Re: Oregon State Agency Comments on FERC's Draft Environmental Impact Statement for
Docket Nos. CP 17-494-000 and CP 17-495-000 (Jordan Cove Energy Project LP and
Pacific Connector Gas Pipeline LP)
DOJ File No.: 0ES456-ES456

Oregon State Agency Comments
Jordan Cove Energy and Pacific Connector Gas Pipeline Project
Draft Environmental Impact Statement
(Docket # CP17-494-000 and CP17-495-000)
July 3, 2019

Figure 2 of 47 from PCGP's Geologic Hazards Maps (Northwest of Milepost 8R):

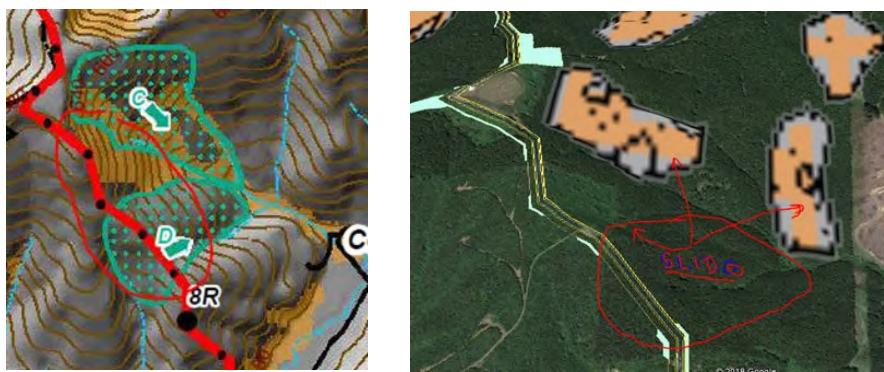
<p>PCGP's Erosion Control and Revegetation Plan does not indicate if the Temporary Work Area above the unstable slope feature will be used to store spoils (soil, boulders, root wads) and logs from forest clearing. However, PCGP's Resource Report 1 indicates that PCGP may use these work areas for these purposes. The ECRP does not detail how PCGP will manage construction stormwater above this unstable feature. Stormwater discharge at the top of convergent headwalls and bedrock hollow adds load to the top of this unstable slope. This stormwater discharge may create a positive soil pore pressure leading to a landslide. PCGP has not provided DEQ with an engineered post-construction stormwater management plan for the permanent pipeline right-of-way for this area and others indicating how PCGP will manage drainage above unstable slope features.</p> <p>On page 35 of Resource Report 6, PCGP discusses two primary ways in which pipeline construction has the potential to adversely impact slope stability. PCGP notes in Report 6 that routing drainage to potentially unstable slopes has the potential to adversely impact slope stability. However, PCGP does not provide DEQ with an analysis using the slope stability models to identify unstable slopes noted in DEQ's review of PCGP's response to Comments 6 and 7. Additionally, PCGP does not provide DEQ with a construction and post-construction stormwater management plan demonstrating how specifically PCGP will manage stormwater along these unstable landscape features.</p> <p>PCGP only identifies slope breakers along the construction and permanent right-of-way as the only technique to manage construction and post-construction stormwater. PCGP does not discuss, for example, or demonstrate the application of cutoff trenches presented in technical manuals on stabilizing slopes. PCGP does not detail the grade and placement of slope breakers on the ground in engineering plans for the construction and permanent right-of-way. Without this information as well as the drainage pattern, DEQ is unable to determine if the proposed use of slope breakers alone is sufficient to prevent the addition of weight from stormwater and an increase in soil pore pressure on an unstable slope.</p> <p>With the current submittal, DEQ cannot determine if the proposed slope breakers highlighted in the Erosion Control and Revegetation Plan will prevent landslides due to pipeline construction and operation. Additionally, in Resource Report 6 and the proposed ECRP, PCGP does not address site-specific constraints (i.e., roads, unstable landforms on each side of the right-of-way etc.) that may limit the application of slope breakers to route drainage away from unstable slopes. PCGP is proposing to remove trees and shrubs to install this gas pipeline. This loss of tree interception will increase the volume of runoff generated along pipeline's construction and permanent right-of-way. The discharge of this additional runoff among these unstable slope features has the potential to impact water quality.</p> <p>The following are two more examples highlighting similar concerns discussed in DEQ's review immediately above.</p>

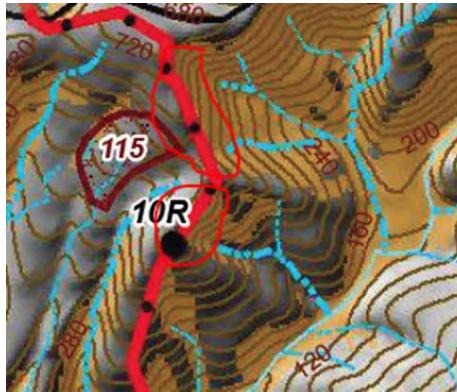
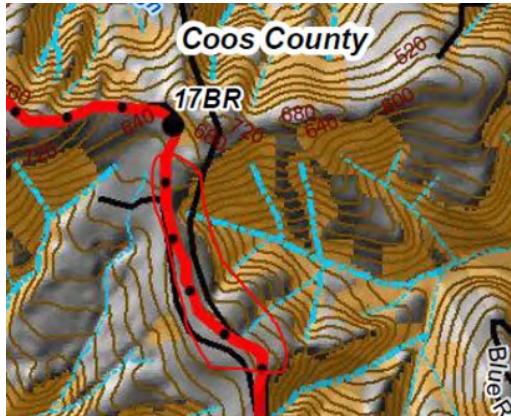
<p>PCGP's ECRP does not show the engineering analysis and its technical support for how PCGP will manage the construction and post-construction stormwater above the Area of a Rapidly Moving Landslide Hazard and convergent headwall.</p> <p>2. No Engineering Designs for Fill Slopes on Steep, Unstable Slopes and/or Steep Slopes with Erosive Soils</p> <p>In Resource Report 6 (Geologic Resources), PCGP provides few specifics regarding controls to stabilize slopes to prevent landslides. Moreover, as noted in DEQ's review of PCGP's response to Comment 35 below, PCGP provides no engineering designs and the technical support for these designs for stabilizing fill slopes on steep, unstable slopes greater than 30% including slopes with highly erosive soils. PCGP identifies this deficiency on page 35 of Section 4.6.2 of Resource Report 6 by stating the following:</p> <p style="padding-left: 40px;"><i>Steep side slope Pipeline construction segments will be identified during the final design phase of the Pipeline project. Fill slope construction details and specifications will be designed for the identified steep side slope Pipeline segments.</i></p> <p>In Section 11.0 (Steep and Rugged Terrain), PCGP provides only a qualitative description of how it may approach fill slopes on steep, unstable slopes starting at the bottom of page 47. However, this mostly qualitative discussion does not consider terracing on erosive soils nor does it thoroughly address the management of stormwater on a terraced fill slope. The management of drainage on these steep slopes, the use of geotextiles or other engineering techniques to support terracing, and the need to reinforce the toe of slope are also not addressed in PCGP's submittal. These are issues typically addressed in technical references developed to construct linear infrastructure such as roads on steep slopes. However, PCGP does not discuss or addressed these issues in PCGP's submittal.</p> <p>3. Unclear Design Standards/Specifications for Needed Road Improvements and Maintenance Standards/Specifications for Existing Access Roads</p> <p>PCGP is proposing to use more than 660 miles of roads to construct this gas pipeline and its associated components. PCGP lists the Transportation Management Plan in Appendix A part 2 of the Water Quality Package as PCGP's approach to comply with water quality standards. As highlighted below, PCGP has not provided DEQ with specific road maintenance standards for access roads PCGP will use to construct and operate the pipeline. As highlighted below, PCGP has not provided DEQ with designs and specifications for any identified improvement to these existing access roads nor has PCGP demonstrated it conducted an inventory of the current condition of all access roads to determine their capacity to support the proposed level of use while minimizing the impact of these access roads on water quality.</p>

**Location of PAR-113.66 and the reconstruction of BLM Noninv
32-2-36.A. Drawing No. 340.31-Y-Map 14, Sheet 32, 55**

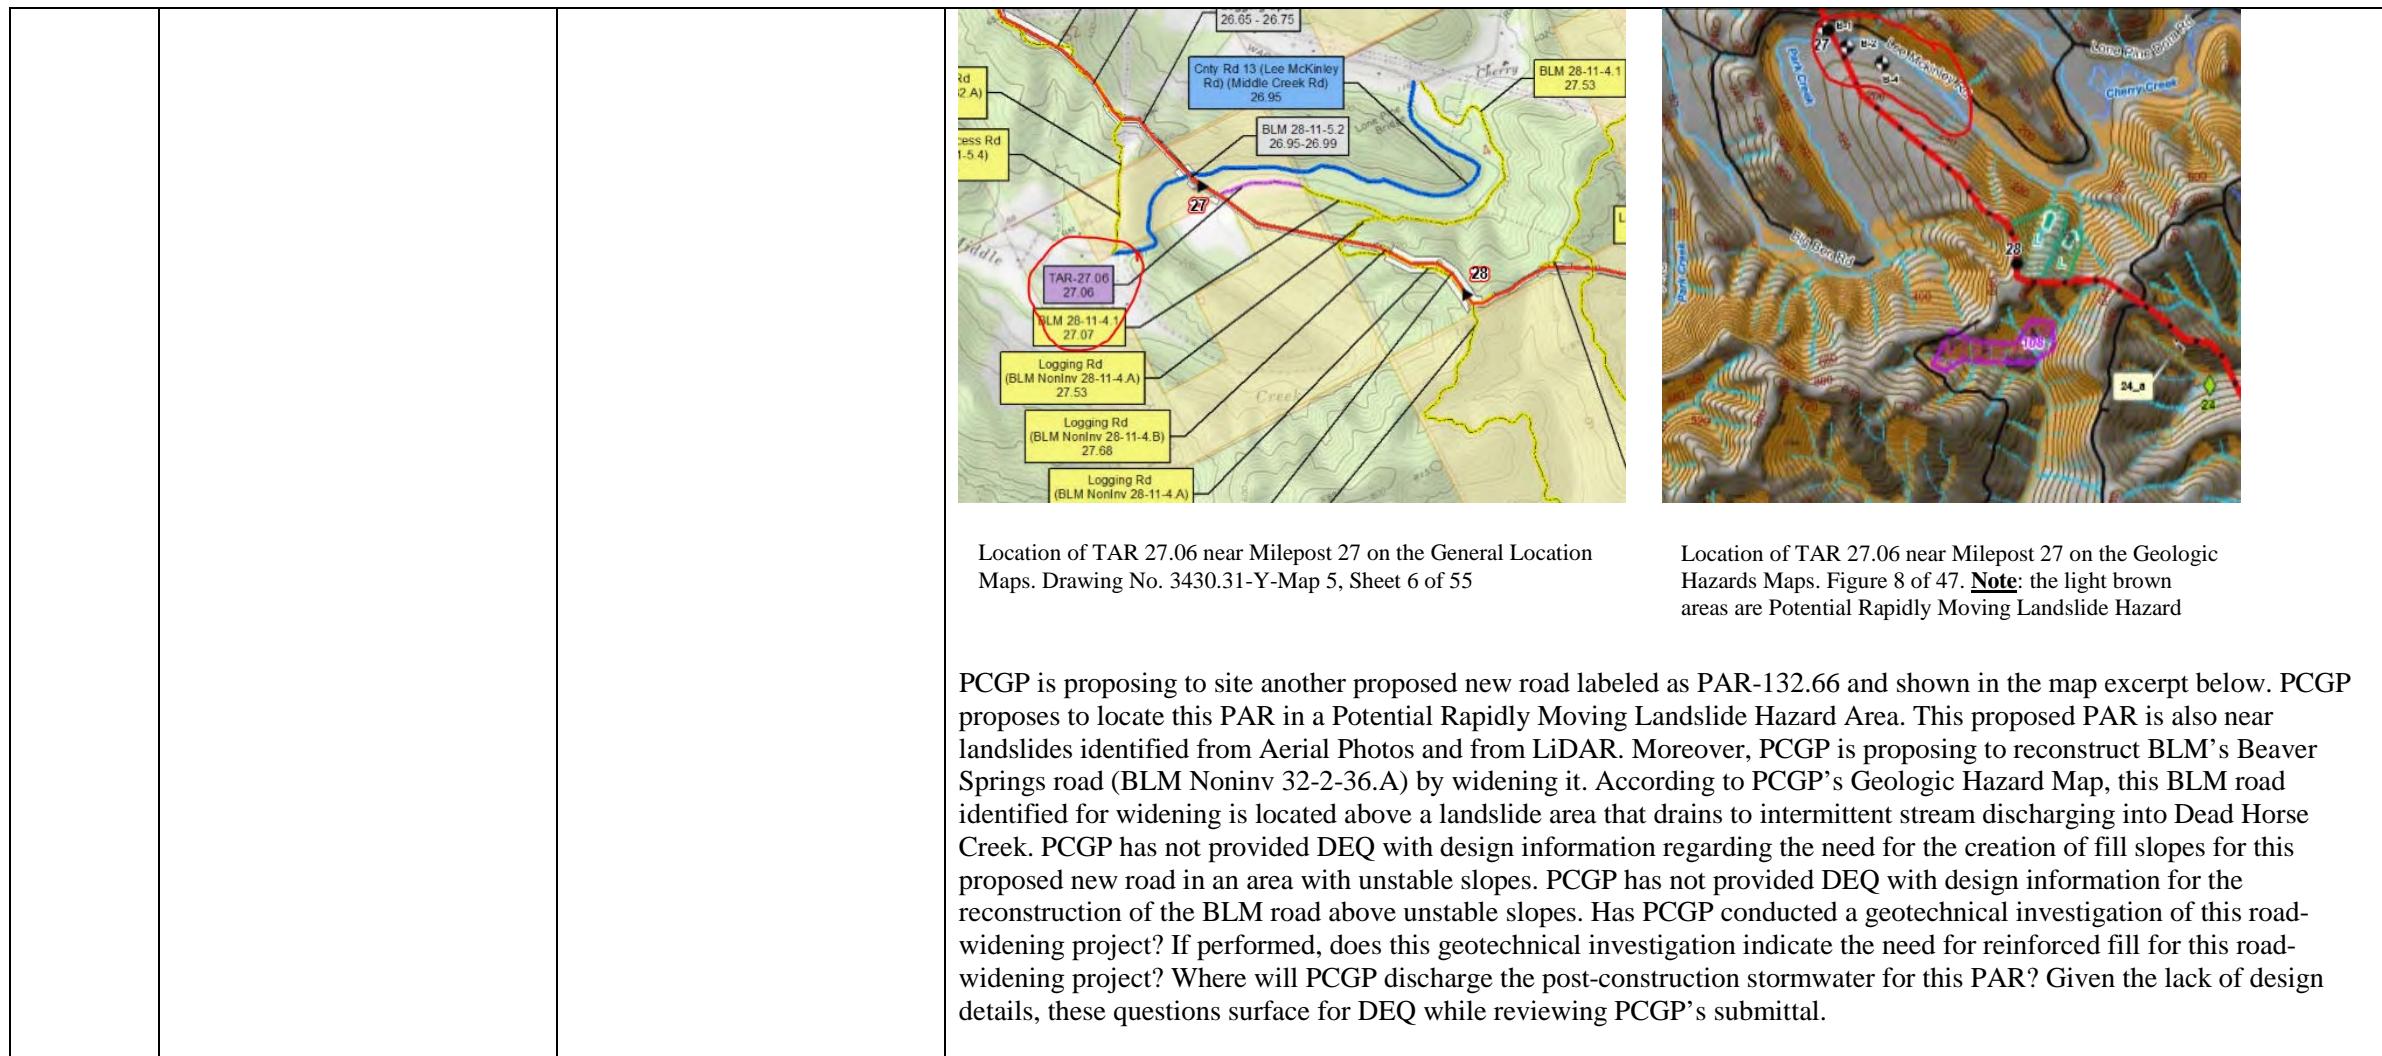
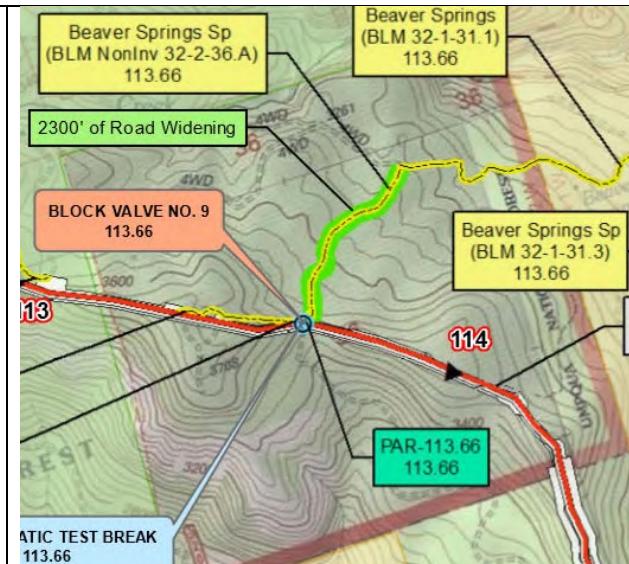
<p>the revised table to ODEQ in Q4 2018.</p>	<p>Location of TAR 101.70 near Milepost 102 in Part 2 JPA Appendix B, General Location Maps, Drawing No. 340.31-Y-Map 14, Sheet 27, 55</p> <p>As noted in DEQ's review of PCGP's response to Comment 15, the Oregon Department of Forestry uses rules developed under the Oregon Forest Practices Act to comply with Total Maximum Daily Loads and with water quality standards. In ODF's memorandum of understanding with DEQ referenced in DEQ's review above, ODF states that it has adopted water protection rules in the form of BMPs for forest operations "including, but not limited to, OAR Chapter 629, Divisions 635-660." With the limited information that PCGP provides, DEQ is unable to determine if PCGP is complying with the following Forest Practices Act rule (OAR 629-625-0200):</p> <p>Road Location</p> <p>(1) <i>The purpose of this rule is to ensure roads are located where potential impacts to waters of the state are minimized.</i></p> <p>(2) <i>When locating roads, operators shall designate road locations which minimize the risk of materials entering waters of the state and minimize disturbance to channels, lakes, wetlands and floodplains.</i></p> <p>(3) <i>Operators shall avoid locating roads on steep slopes, slide areas, high landslide hazard locations, and in wetlands, riparian management areas, channels or floodplains where viable alternatives exist.</i></p> <p>(4) <i>Operators shall minimize the number of stream crossings.</i></p> <p>(5) <i>To reduce the duplication of road systems and associated ground disturbance, operators shall make use of existing roads where practical. Where roads traverse land in another ownership and will adequately serve the operation, investigate options for using those roads before constructing new roads.</i></p> <p>Moreover, PCGP has not provided DEQ with any information indicating that it has investigated the constraints associated with the proposed site for TAR 101.70. PCGP has not developed engineering solutions – with associated technical support – to avoid debris flows into East Fork Stouts Creek or the intermittent streams below the fill slope of this proposed road sited in an area identified as hazard for Rapidly Moving Landslides. Hearn 2011 provides techniques for planning new road construction on steep mountainous terrain and include the following as stated in his book:</p> <p><i>B1.2.1 New Road Construction</i></p> <p><i>The techniques listed in Table B1.3 are variously applicable to all project phases, but they offer the greatest application to new road construction projects as an aid to route corridor selection and</i></p>	<p>Area where TAR 101.70 will be located in Resource Report 6, Appendix F, Figure 22 of 47. Note: the light brown areas are Potential Rapidly Moving Landslide Hazard</p>

Location of PAR-113.66 and Proposed Road Reconstruction relative to landslide features. Figure 25 of 47. **Note:** the light brown areas are Potential Rapidly Moving Landslide Hazard
